WS-107A-1 OPERATIONAL BASE
LINCOLN A.F.B., NEBRASKA
SMS-551-10 ELMWOOD

U.G. POWER & COMMUNICATION PLAN

THIS PLAN ACCOMPANIES CONTRACT DA 25 086-ENG-6186 MODIFICATION NO. 57

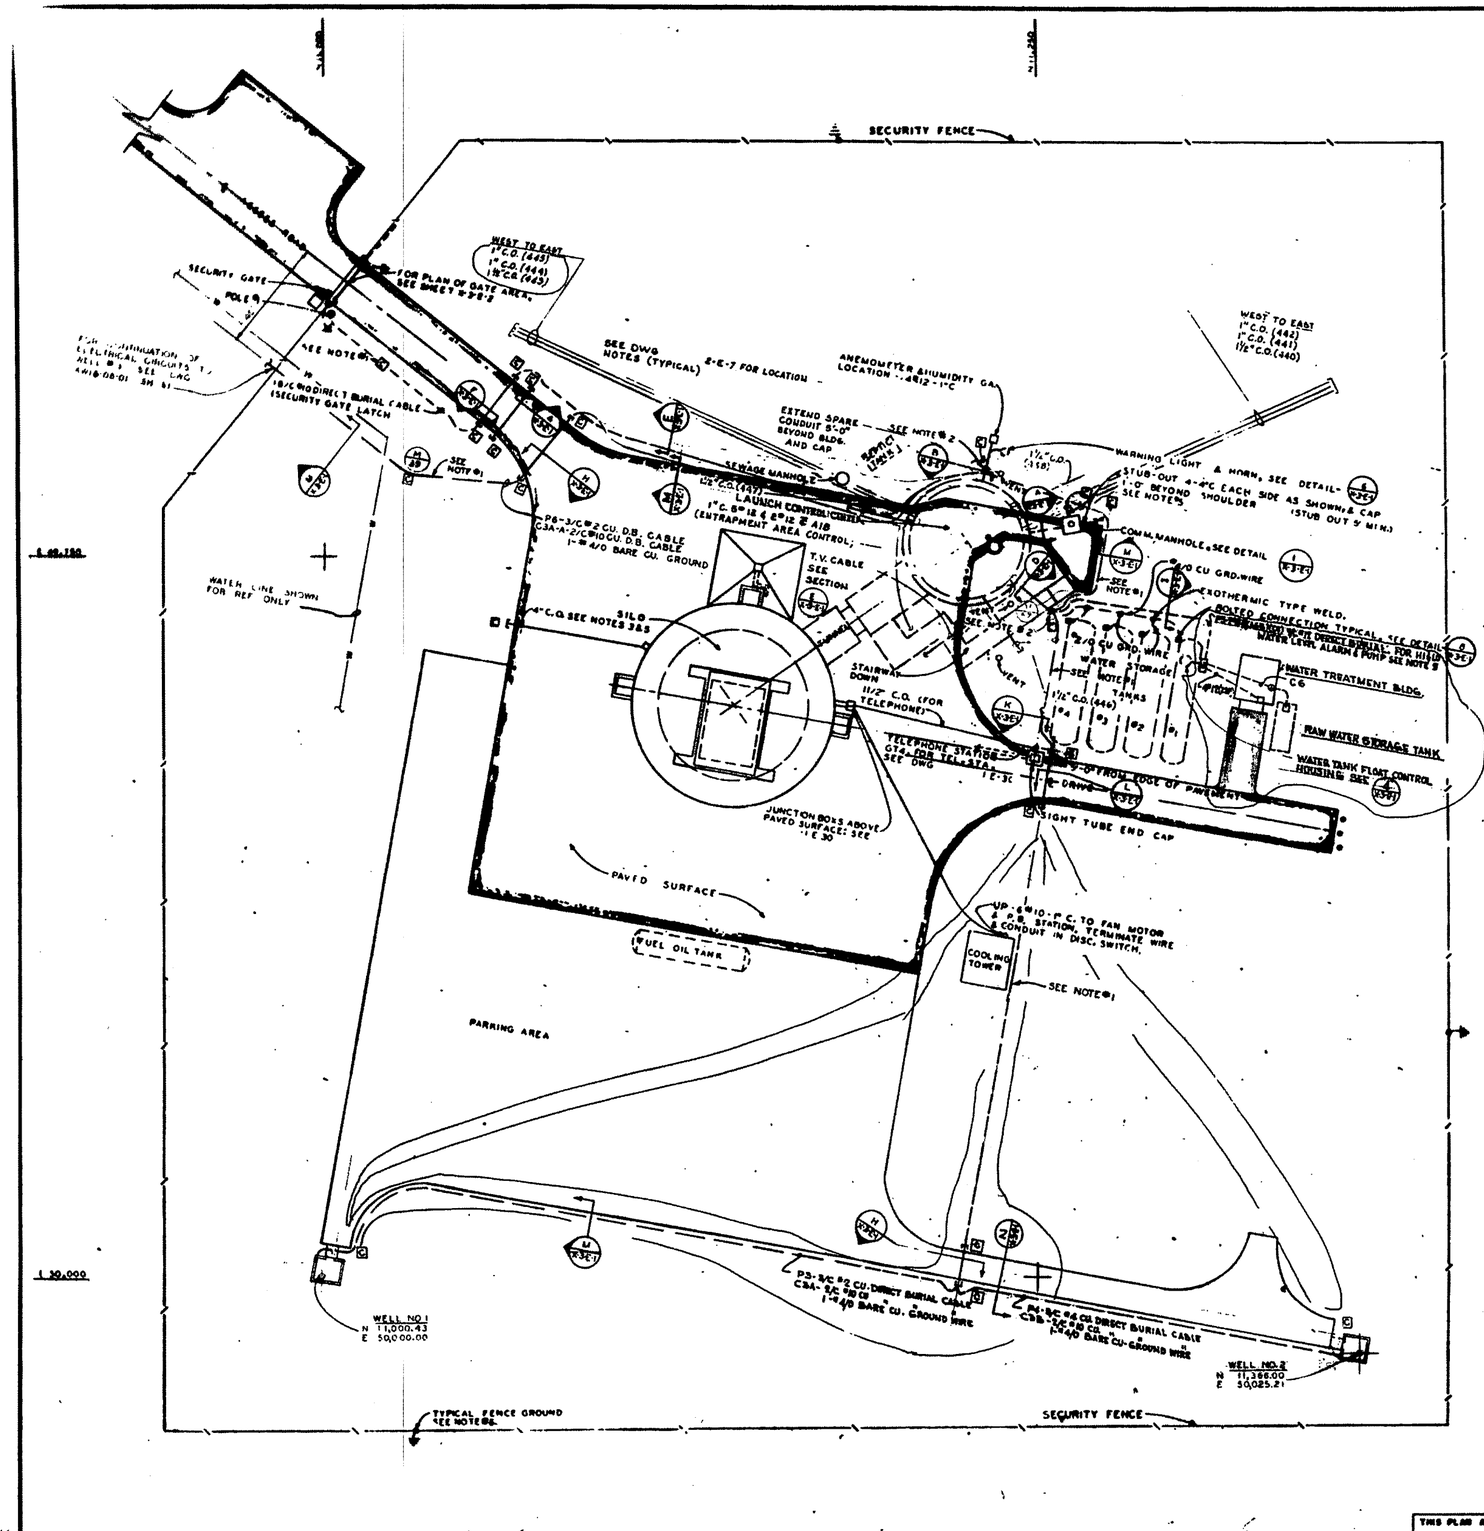
1. (a) DELETED SURVEILLANCE T.V. AMBER & GREEN LIGHT DETECTOR
   (b) REROUTED GATE T.V. CABLE TO ENTRY TUNNEL
   (c) ADDED (5) 1½"C.O. & (4) 1"C.O. FOR BLAST DETECTION SYSTEM
   (d) ADDED REFERENCE DWG -2-E-7
   (e) ADDED 1"C - 5#12 & 2#12 & AIB FOR ENTRAPMENT AREA CONTROL
   (f) DELETED POLE No 8 AT GATE

REVISION	DATE	DESCRIPTION	DESIGNED	DRAWN
	5-29-62	REVISED TO SHOW CONSTRUCTION AS BUILT CONDITION. ADDED WATER TREATMENT BLDG., RAW WATER STORAGE TANK, J.B., C.B., PS & 4"R (TYP.) RELOCATED CABLES (DELETED NOTE 8 ADDED NOTE 9).	CERNICO	G.P.
	10-19-60	ADDED WATER WELL #1, #2, & #3	B.&V.	RFR
M-38	9-27-60	SEE REVISION NOTES	DESIGNED	DRAWN
	9-17-60	NEW DRAWING ADDED	B.&V.	RFR
